Enclosure 5

LAR Supplement to Address Audit
Discussion Points Summarized in NRC
Letter Dated September 14, 2021
(ML21238A138)

Summary of Discussions and Ameren Missouri Responses

Figure Q8.1. Generic schematic of heater nozzle (sleeve) installation at the bottom of the pressurizer.

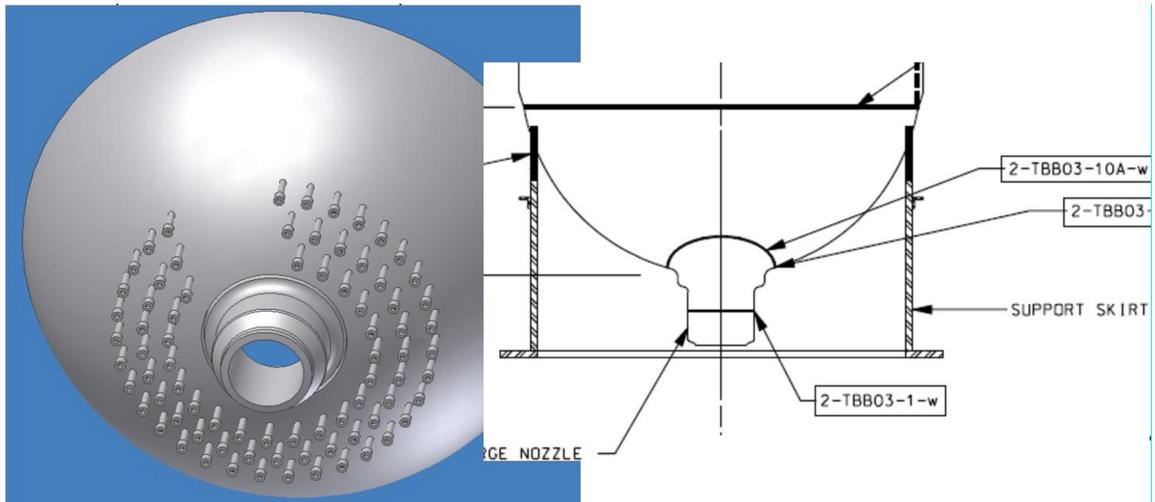
- (8) The NRC staff notes that besides the potential for pipe weld failures, there are other potential failures from non-pipe components in the reactor coolant system (RCS) pressure boundary such as steam generator manways, pressurizer nozzles (e.g., heater sleeves, safety and relief valves), pump bodies, and mechanical joints. Clarify whether the non-pipe components mentioned above were selected as a break location and evaluated for debris generation. If not, provide justification.

The licensee stated that the failure locations identified by this item are considered to be secondary risk contributors. The NRC stated, that for completeness, these potential break locations should be identified and evaluated to ensure that they do not contribute significantly to risk. The licensee stated that it will review the submittal to make sure that break locations of this type are identified and quantitatively or qualitatively screened to show that the risk contribution is insignificant to the overall risk quantification.

The response to audit question 34 provided in this supplement provides a survey of component failures that are identified in the PRA as having a potential to lead to sump recirculation, including bolted manways on the steam generator and pressurizer, pressurizer safety and relief valves, and bolted flange connections (mechanical joints). Reactor coolant pump (RCP) seal failures are also addressed in the response to question 34. All event scenarios listed in this question #8 (and many other scenarios listed in the question 34 response, such as control rod drive ejection) are screened from further consideration in the risk analysis because they have limited potential for debris generation (comparable to a 2-in. LOCA) and/or have much lower recirculation flow rate requirements than the large break LOCA (LBLOCA) conditions tested to establish a 300-lbm transported fiber limit. The response to audit question 35 explains the importance of reduced flow rate during recirculation.

Pressurizer heater nozzles (sleeves) are not included in the list of Class 1 welds that are quantified as primary risk contributors because each weld is small and they are located under the steel pressurizer support skirt that is credited as a robust barrier to limit ZOI size. (See Figure Q8.1.) RCP body failures were not considered explicitly because seal failures are considered a more likely location for pressure boundary breach related to pumps. RCP Seal LOCAs are assumed to have debris generation potential smaller or comparable to a 2-in pipe break and do not contribute to risk of ECCS failure.

Potential failures from non-pipe components in the reactor coolant system (RCS) pressure boundary were not selected for specific debris generation analysis because they are screened from having any significant contribution to the overall risk quantification. It is important to note that the prevalence of large Class 1 welds near all non-pipe components ensures that all combinations of debris have been examined in the analysis. There are no special or problematic insulation applications specific to non-pipe component break locations that have not been included as targets in pipe-weld break simulations.

Figure Q10.1. FOAMGLAS® insulated lines in Callaway containment (red).

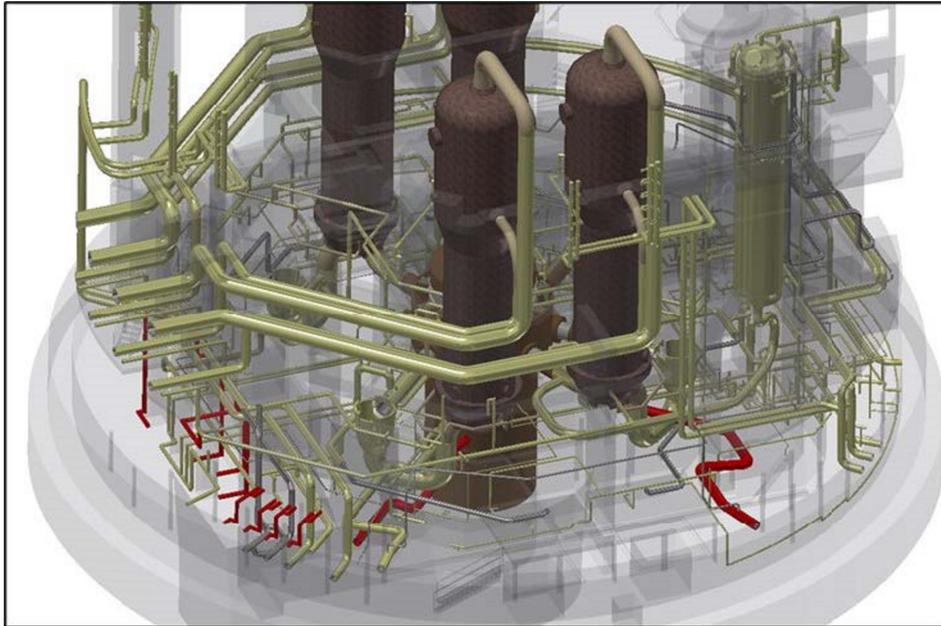
- (10) In LAR Enclosure 3, on pages 12 and 17, the licensee states that FOAMGLAS® is treated as fiber and that this results in an overprediction of risk due to the additional LDFG being transported to the strainer. Considering the relatively low particulate debris margins for some cases, how was this evaluated? The NRC staff would be able to perform confirmatory calculations for this issue if a database of debris generation and transport for each break scenario, including FOAMGLAS®, is made available to the staff. This is related to a question in the Risk-Informed Bases section and the request for the spreadsheet of debris generation and transport.

The licensee stated that the material was initially modeled as Nukon but was later identified to be FOAMGLAS®. The licensee explained that a supplement will provide additional details on how the debris source is treated in the risk analysis. The information will include results of testing conducted to assess the transport properties of the material, assumptions regarding its contribution to chemical effects, the acceptability of the amount of fiber assumed to be generated (based on the material density vs. Nukon density), and will address the consequences that could occur if the material was transported to the strainer and behaved as particulate. This item is related to Item 33 of this Appendix. The issue is also related to Item 20 of this Appendix as the resolution for Item 20 may result in additional margin in the particulate debris source term.

Pipes discovered to be insulated with FOAMGLAS® were modeled as NUKON® fiberglass in all debris generation and transport calculations. This means that these pipes were affected by the 17D ZOI applied for NUKON® and that the corresponding debris quantities and sizes were included in all RoverD comparisons to the 300-lbm fiber test limit. The additional fiberglass applied to these pipes represents a 350-lbm safety margin of excess fiber assumed to be present in containment. Not all of this material can be damaged by every break, but the fiber debris generated by some breaks may have exceeded the 300-lbm fiber test limit and contributed to Δ CDF because it impacted pipes actually insulated with FOAMGLAS®. Equivalent quantities of the two insulation types are based on insulation thickness applied to specific lines in the CAD model. FOAMGLAS® is assumed to have a midrange

density of 8 lbm/ft³ and NUKON® is assumed to have a density of 2.4 lbm/ft³. Figure Q10.1 illustrates the location of FOAMGLAS®-insulated pipes in containment.

Evaluation of FOAMGLAS® as LDFG instead of particulate is judged to be conservative based on the following argument. The total amount of FOAMGLAS® in containment is 1167 lbm. Twenty-five breaks that do not contribute to Δ CDF have less particulate margin than 1167 lbm. The minimum particulate margin for the 25 breaks that do not contribute to Δ CDF is 1081 lbm. If less than 8% (i.e., $(1167 - 1081) / 1167 \times 100\%$) of the total FOAMGLAS® mass does not reach the strainers in a form that causes head loss, treatment of FOAMGLAS® as transportable particulate would not induce an additional contribution to Δ CDF. FOAMGLAS® physical characteristics and the geometry of ZOI debris generation make it very unlikely that more than 92% of the total FOAMGLAS® mass can be degraded into problematic particulates.
